V2500-A1/A5/D5 SERIES PROPULSION SYSTEMS SERVICE BULLETIN

This document transmits the Initial Issue of Service Bulletin V2500-ENG-72-0392

V2500-ENG-72-0392

MODIFICATION SERVICE BULLETIN - ENGINE - LP COMPRESSOR - IMPROVED REPAIR PARTS FOR ACOUSTIC LININGS OF FAN CASE

Repair Parts for Acoustic area - Before and after alteration Figure 1

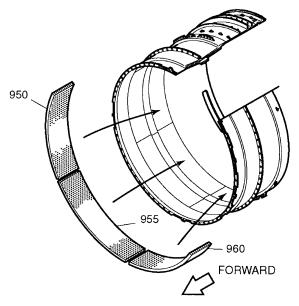
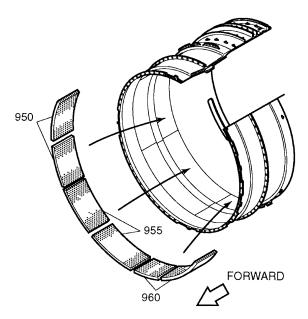
(1) The part introduced by this Service Bulletin must be fitted as a complete location set to increase reliability. This Service Bulletin configuration partitions an old part into two small parts. If old configuration lining became damaged, each one can be removed and replaced with two new configuration linings.

- (1) The change introduced by this Service Bulletin are as follows:
 - (a) The repair only part (P/N: 5R0291) of the fan case assembly have changed as follows:
 - (i) To change the adhesive for perforated skin end of acoustic lining.
 - (ii) To decrease circumferential length of acoustic lining to a half of current parts.
 - (iii) To increase the quantity of acoustic lining to 12 from 6 for each engine.
 - (iv) To provide a water drainage feature and eliminate possibility of incorrect installation.
